EXTENSION &
ALTERATIONS at

FIELD HOUSE,
WHITBY ROAD
ROBIN HOODS BAY

Drawing:
PROPOSED ELEVATIONS I

— = proposed changes to agreed planning NYM/2020/0318/FL

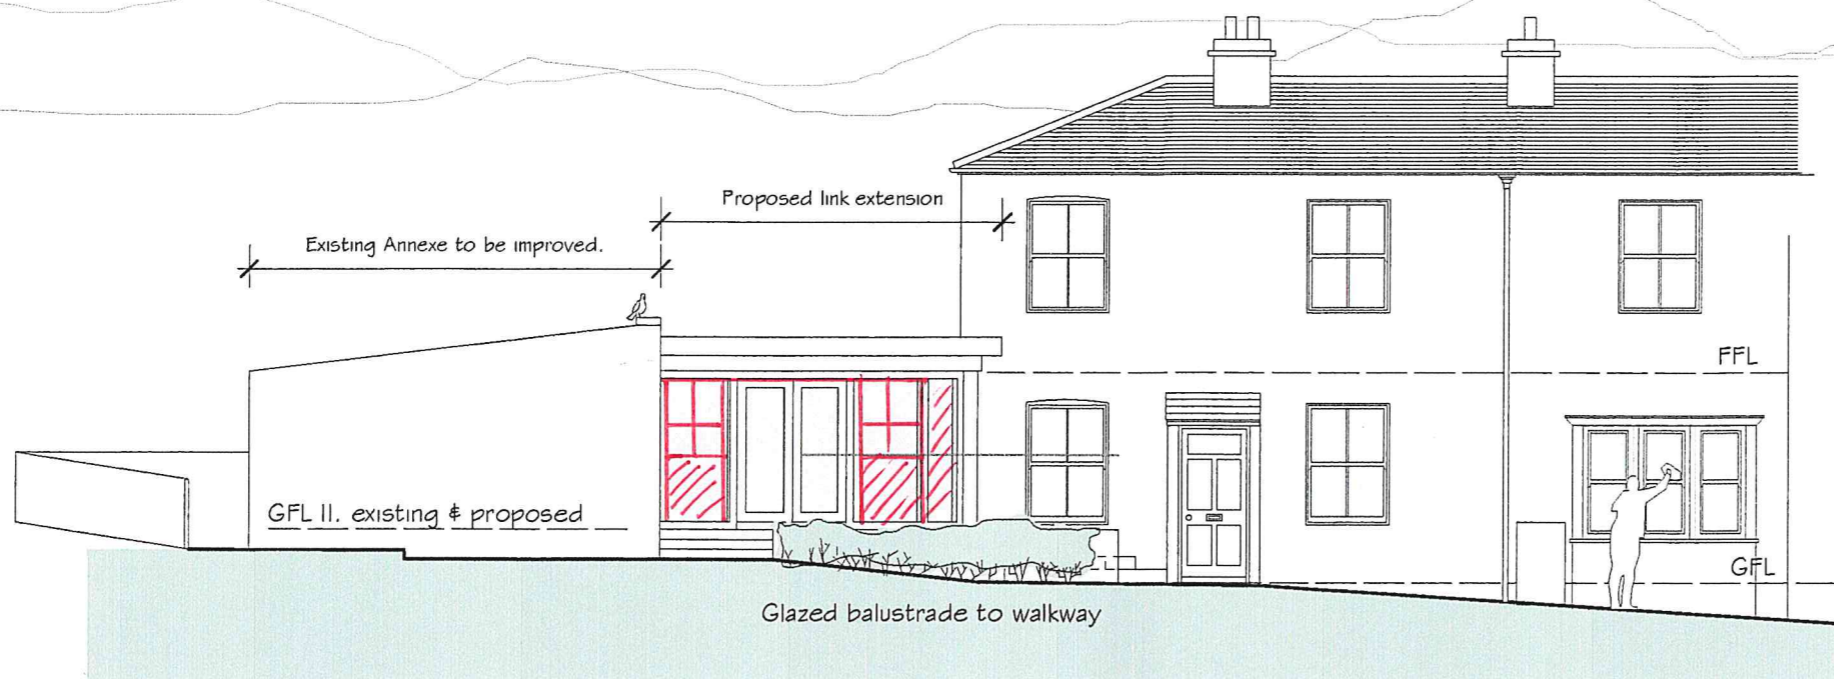
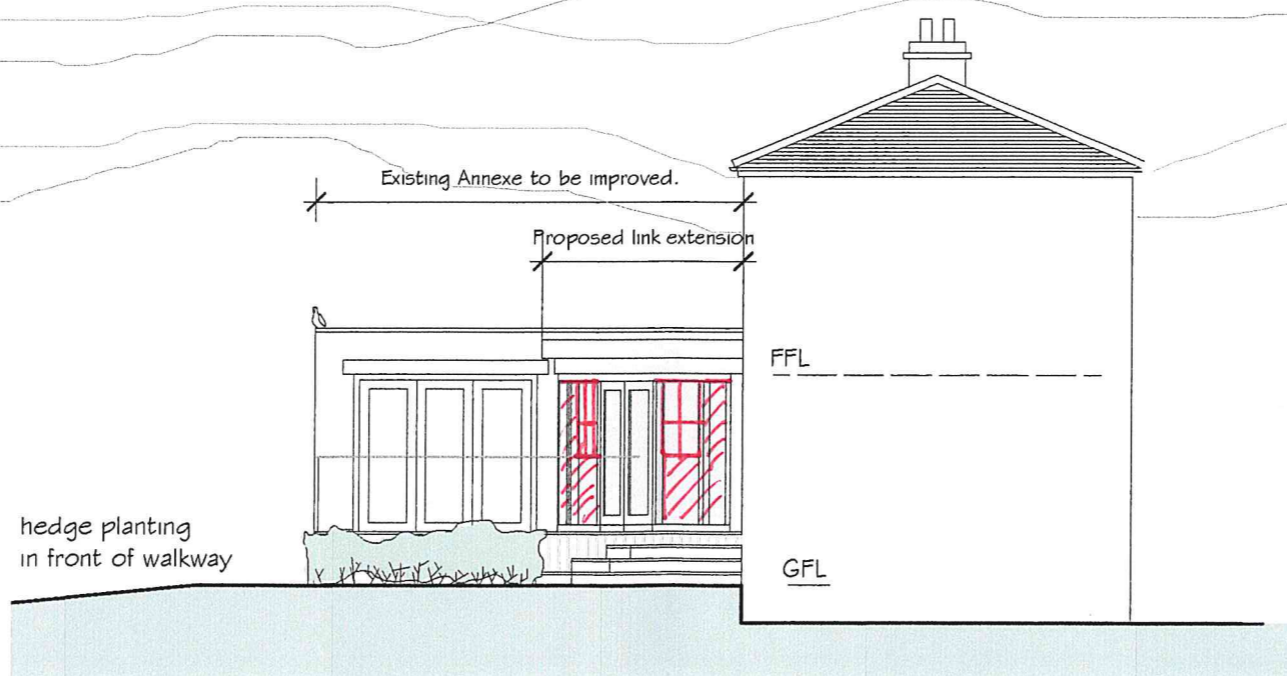
New timber fence to
match existing.

Proposed:
EXTENSION &
ALTERATIONS at
FIELD HOUSE,
WHITBY ROAD,
ROBIN HOODS BAY
Drawing:
PROPOSED ELEVATIONS I

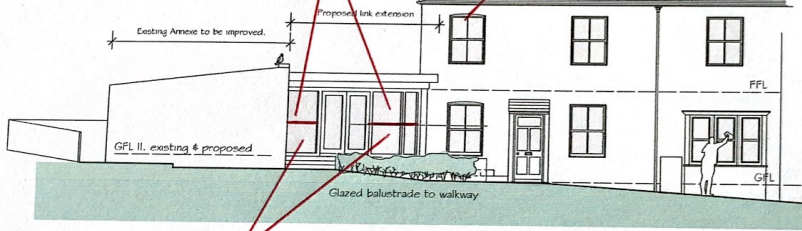
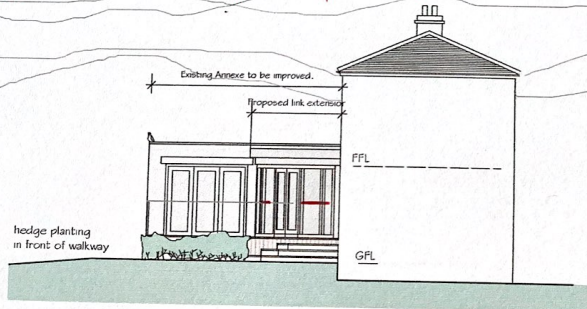
Hand-built wooden
sashes.
Cladding

To replace UPVC windows with
hand-built, wooden sashes, to be more
in keeping with original features. All
current dimensions to be
matched.

New timber fence to
match existing.

masonry with render to match existing building -
approved NYM/2021/0618/CVC
